**CITY COUNCIL AGENDA ITEM**

**AGENDA ITEM:**    **201401611** - 5801 Roswell Road, *Applicant: Zahedi, Inc.*, to rezone the subject property from C-1 (Community Business District) conditional to C-1 (Community Business District) for the development of to allow an addition to the existing commercial building, with concurrent variances

Agenda Item: **201401611 5801 Roswell Road** a request to rezone the subject property from C-1 (Community Business District) to C-1 (Community Business District) to allow for a 2,100 square foot addition to the existing building, with concurrent variances.

**DEPARTMENT OF COMMUNITY DEVELOPMENT RECOMMENDATION**

**LANDSCAPE/ TREE PROTECTION PLAN**  
5801 CARPENTER DRIVE  
LAND LOT 90, DISTRICT 17  
FULTON COUNTY, GEORGIA

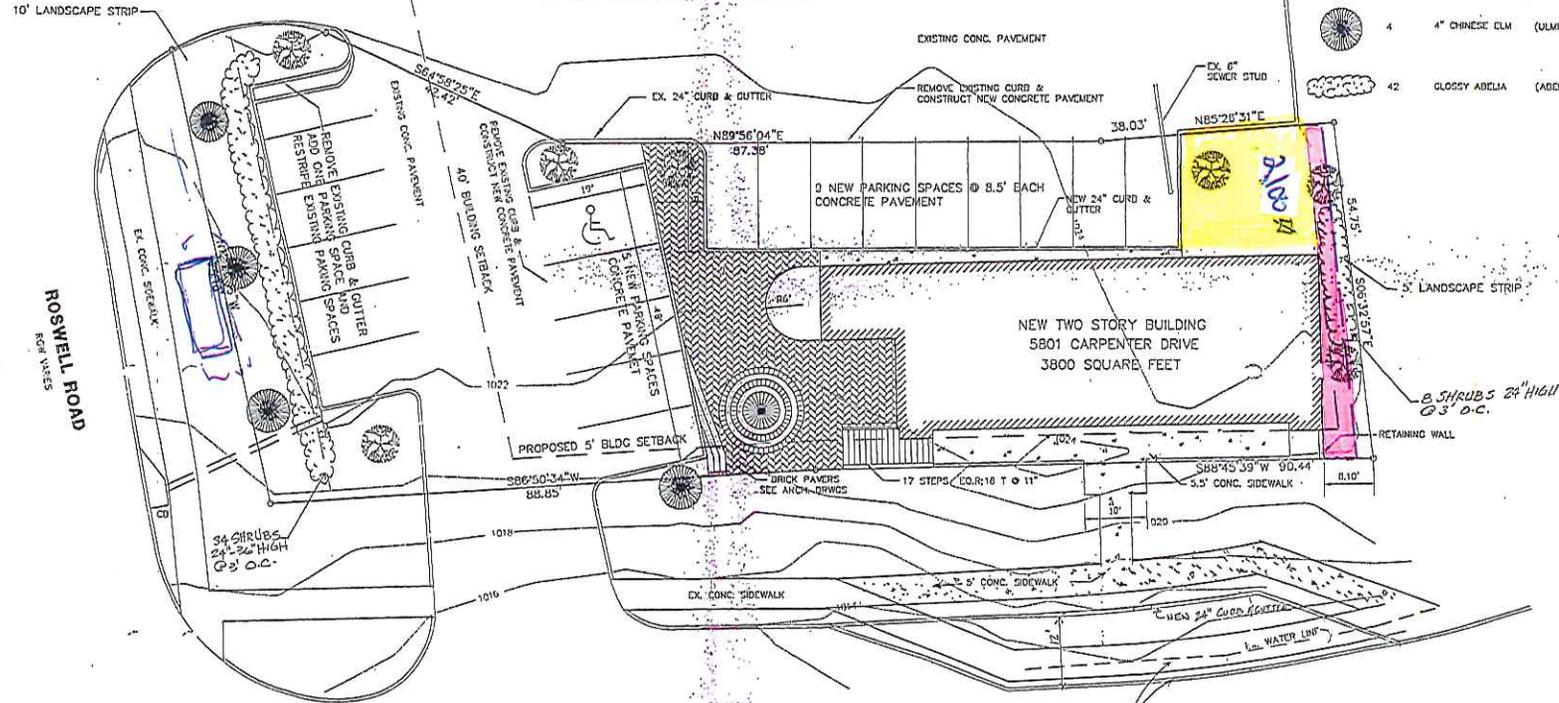
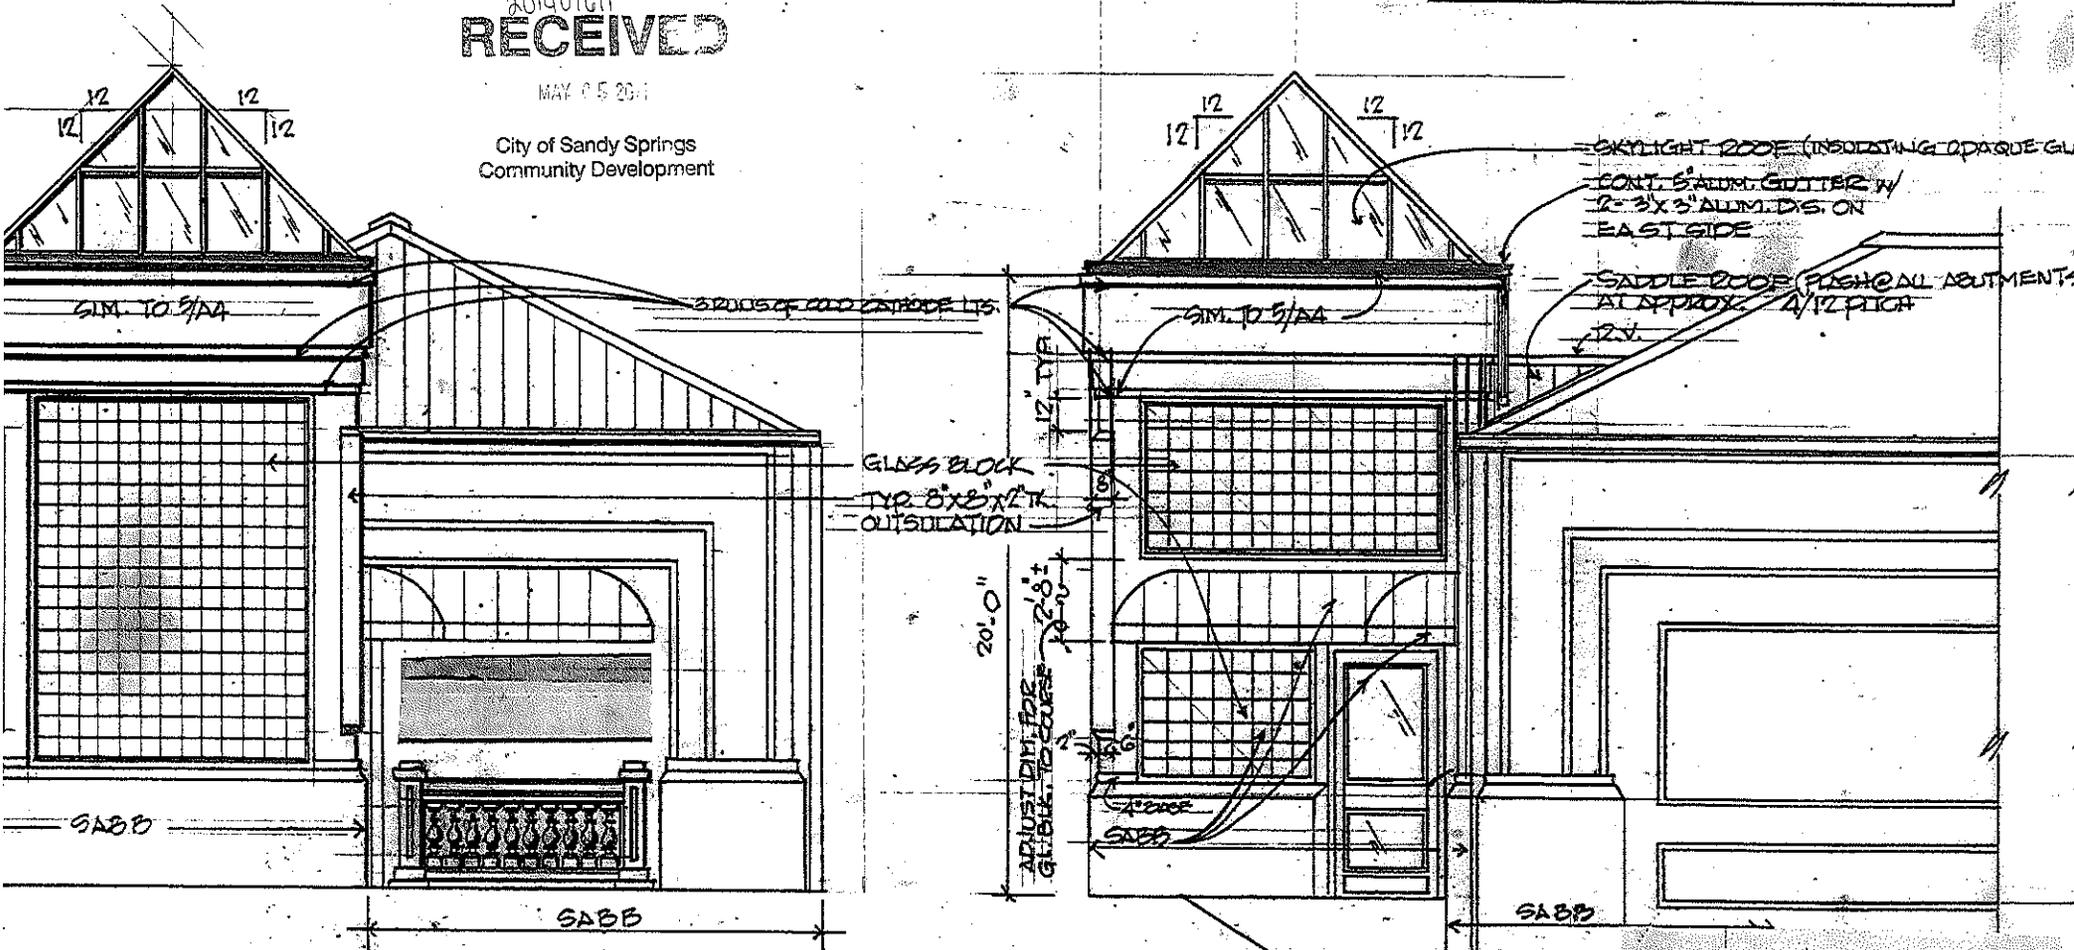
1. Variance from 4.23.1 to reduce the landscape strip from five (5) feet to three (3) feet to allow the proposed addition to encroach along the east property line.

*Staff is of the opinion that the reduction of the landscape strip is in harmony with the intent of the zoning ordinance and would not cause a detriment to the public. The applicant is proposing to square up the back of the building by encroaching two (2) feet in the landscape strip. Additionally the landscape strip will be re-planted. Therefore, based on these reasons, the staff recommends APPROVAL of this variance request.*

3. To the owner's agreement to provide the following site development standards:
  - a. To reduce the landscape strip from five (5) feet to three (3) feet to allow the proposed addition to encroach along the east property line. (CV201401611 #1)

5801 Roswell Road  
 Fulton County, Georgia  
 6-13-2014

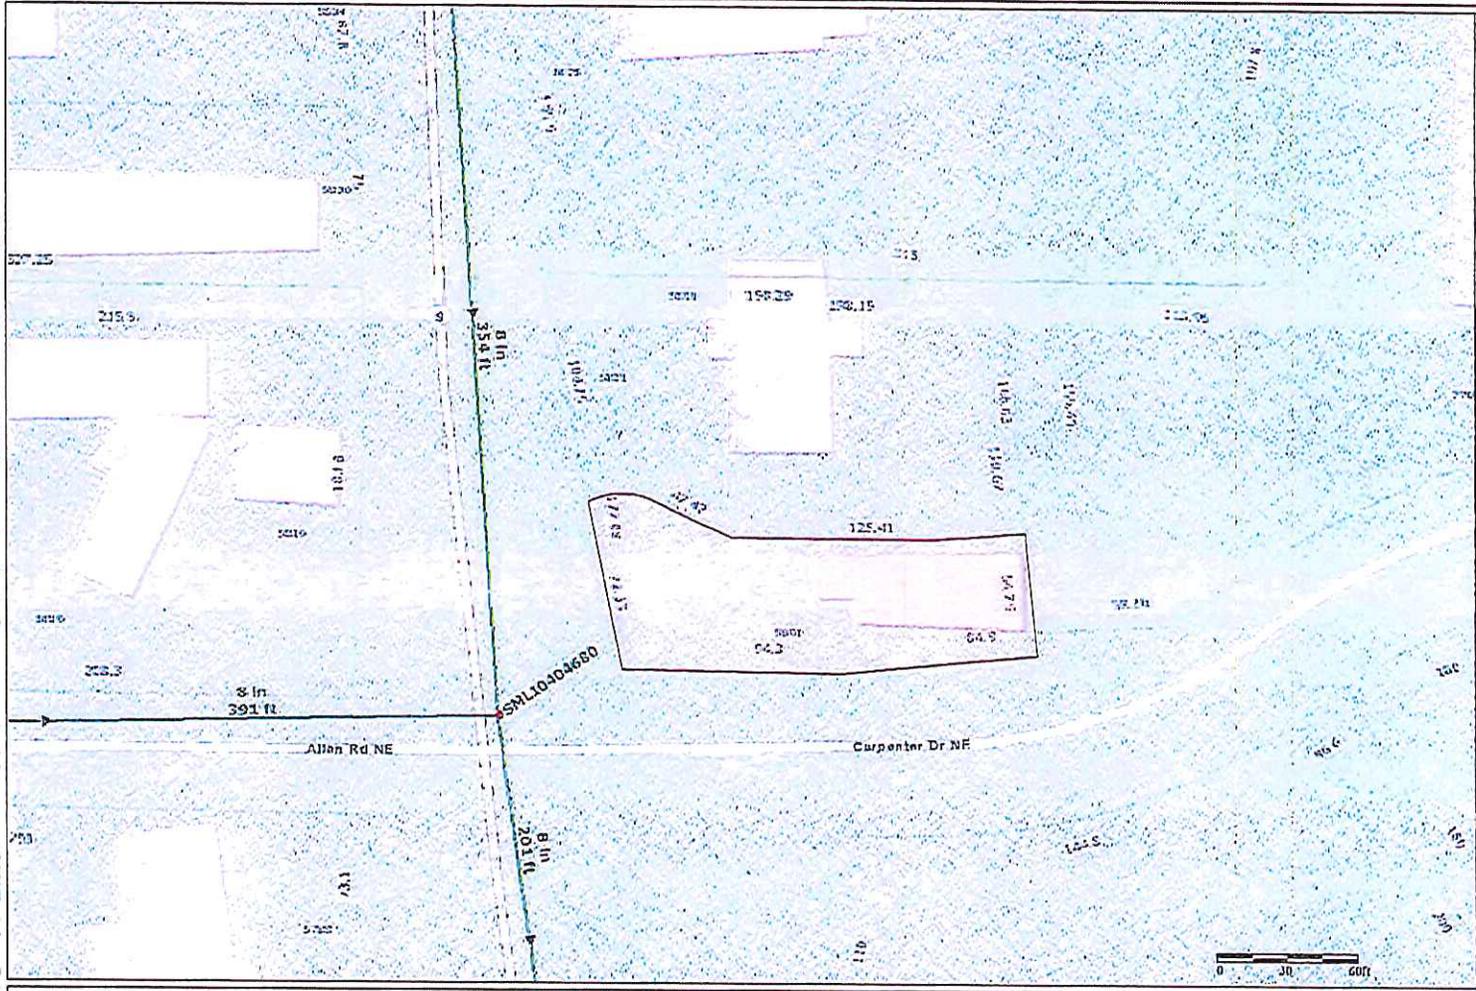
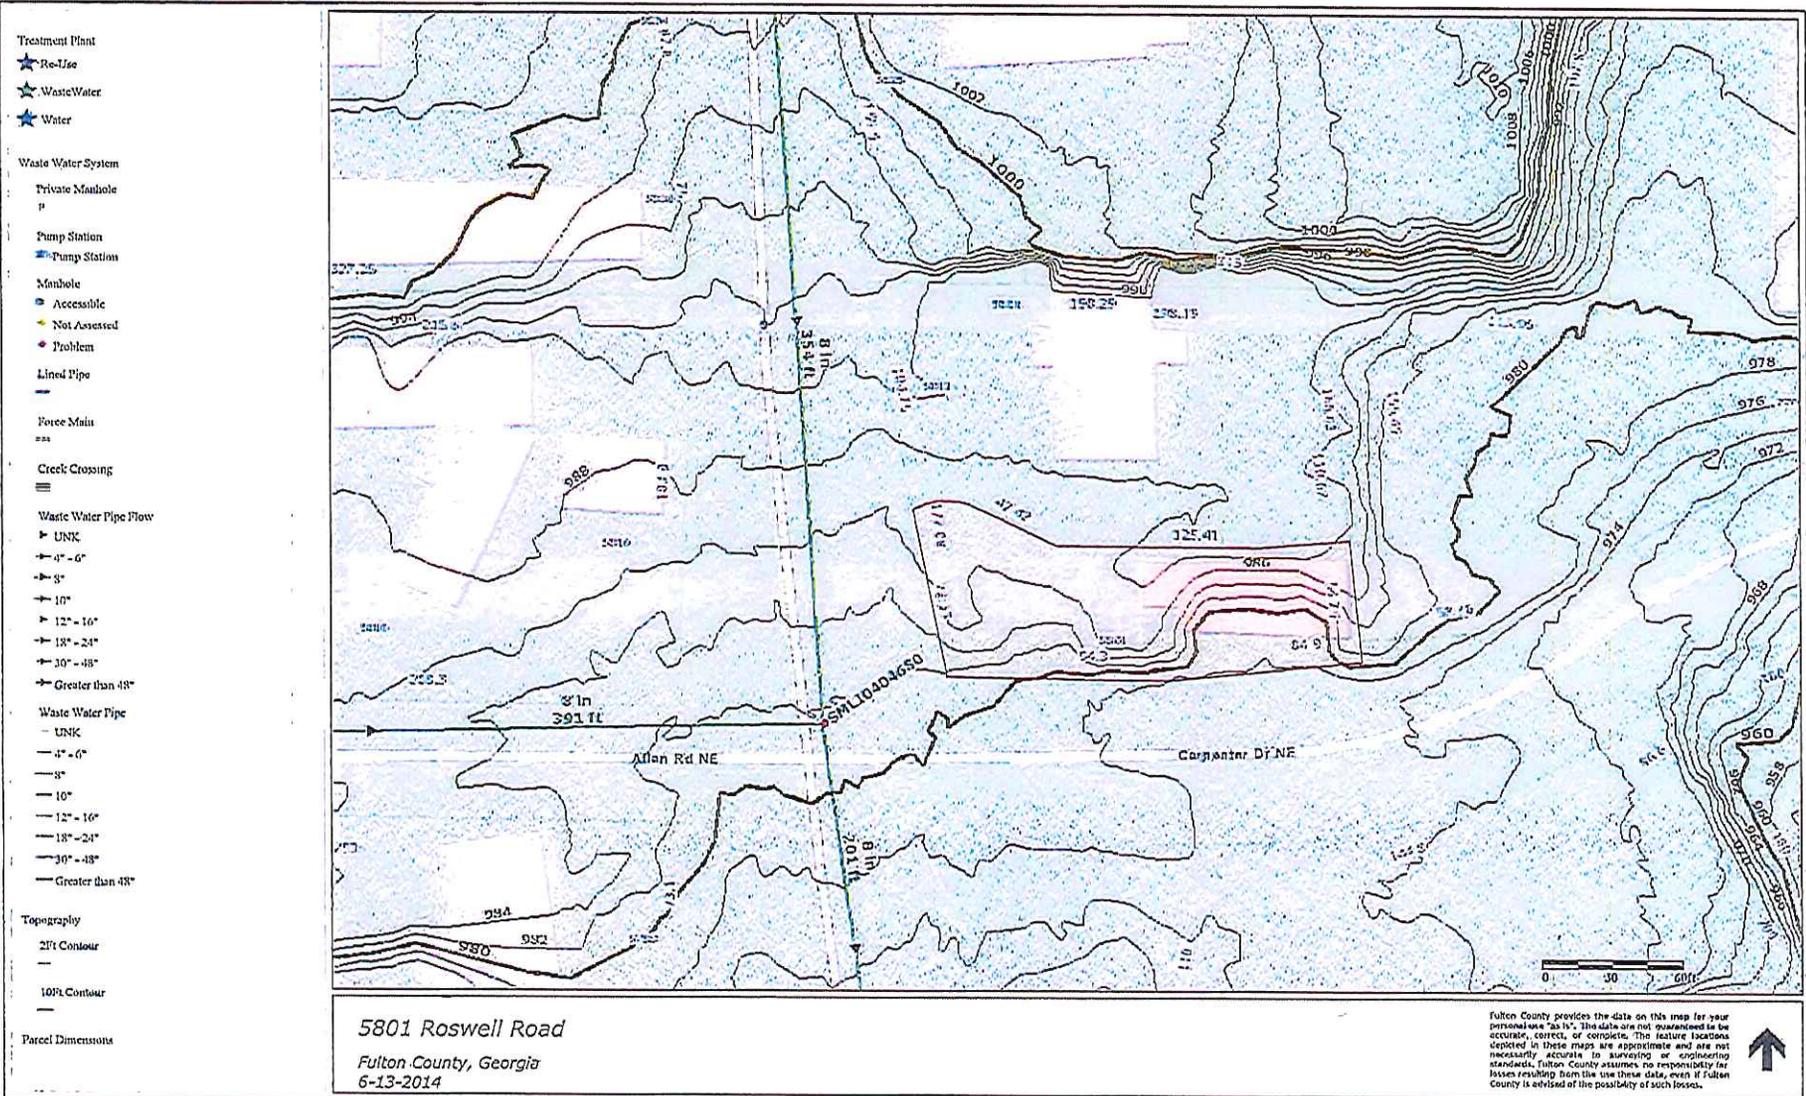
There is a wastewater manhole southwest of the southwest property corner of the 0.246 acre tract (5801 Roswell Road) (Sewer manhole # SMLI0404680) located in Land Lot 90, District 17 that can service this location.

Comments: This information does not guarantee that adequate sewer capacity is available at this time or will be available upon application of permits. Please contact the Department of Public Works for more information.
